TECHNICAL NOTE

2024s0703
Dobfield Road - HRA Addendum
Euan Kellie Property Solutions
15 May 2024
Shantelle Friesen
Jane Crossley and Laura Thomas
Habitats Regulations Preliminary
Screening Assessment Addendum to
Provide Supporting Information

The purpose of this HRA addendum technical note is to provide supporting information to address Natural England's request for further information, specifically as the request relates to Section 5.2.6 of the HRA Screening Assessment.

Figure 3-1. A drawing by S C Bees from 1852 showing puddle clay linings.

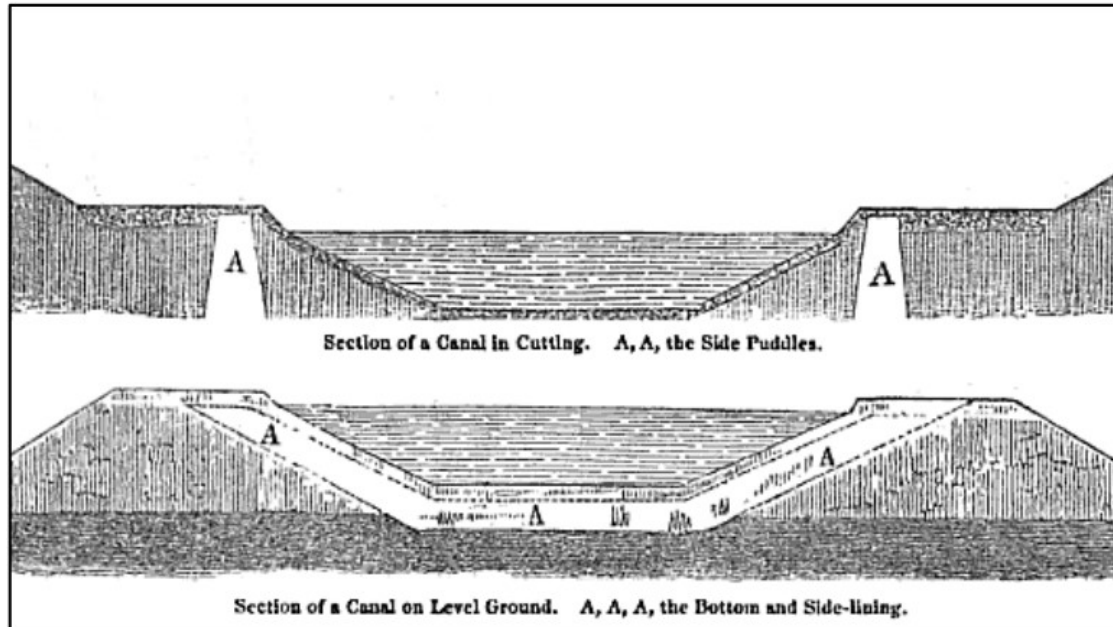
Section 5.2.6 of the assessment outlines the foul sewage treatment for the two plots with 50m of Rochdale canal. This includes individual sewage treatment plants as well as reedbeds as further tertiary treatment before being discharged to a soakaway. Natural England advises that the introduction of reedbeds will help in principle given the size of the discharges however, it should be noted that future maintenance and management of these rest with the individual householders/permit holder.

Further information is required to demonstrate that the drainage measures put in place will meet the surface water and groundwater environmental standards set out by the Water Framework Directive (WFD 2000/60/EC). The HRA should clearly demonstrate how the drainage methods put in place meet WFD 2000/60/EC and as such will not significantly impact the conservation objectives of Rochdale Canal SAC.

Canals in the UK, by design, are lined during construction to inhibit the loss of groundwater through permeable soils, making them 'waterproof'⁴ so that water levels in the canals can be maintained year-round (Figure 3-1⁵). This 'waterproof' design is also preserved during any restoration works⁵ on canals. As such, the design of canals means that not only can water not discharge from the canal into the surrounding ground; groundwater adjacent to a canal cannot enter into the canal water body.

This means that effluent from the proposed STP's cannot enter the Rochdale Canal; therefore, the effluent from the soakaways will have **no likely significant effect** on water quality and/or allow more competitive flora species to thrive and outcompete the qualifying species in the Rochdale Canal SAC.
